## High-Pressure Hydraulic Hose Length Causing Intermittent Pressure Fault

Models Covered	Cummins Serial Number
All CMD/Mercury QSD 2.8L Generation 1 Diesel Axius Products All CMD/Mercury QSD 4.2L Generation 1 Diesel Axius Products	88401303 and above

### Incorrect Hose

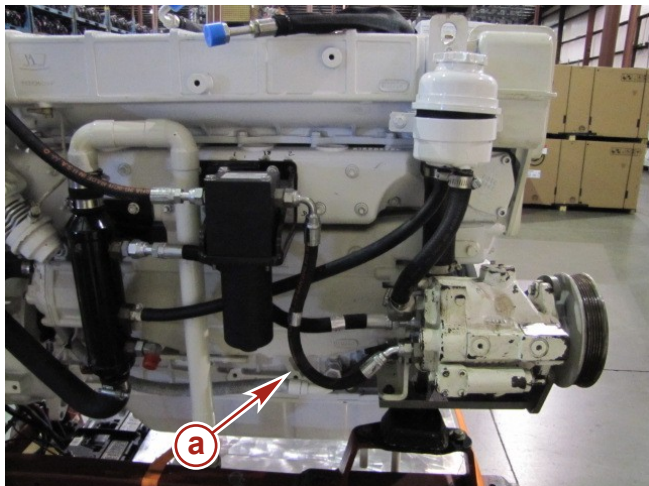
- a -** Requires part number 32-8M0065248 to be ordered and installed

Order and replace with high-pressure hose kit, part number 32-8M0065248.

### Correct Hose Routing

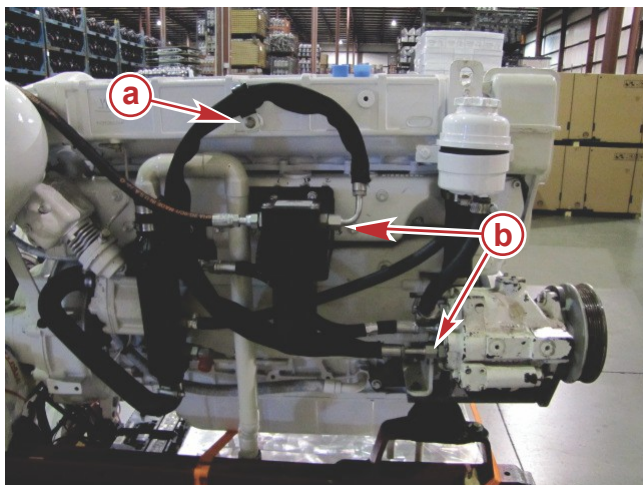
- a -** Hose clamp and bolts  
**b -** Hose swivel fittings

Description	Nm	lb-in.	lb-ft
Bolts (M8 x 12)	19		14
Hose swivel fittings	27		20
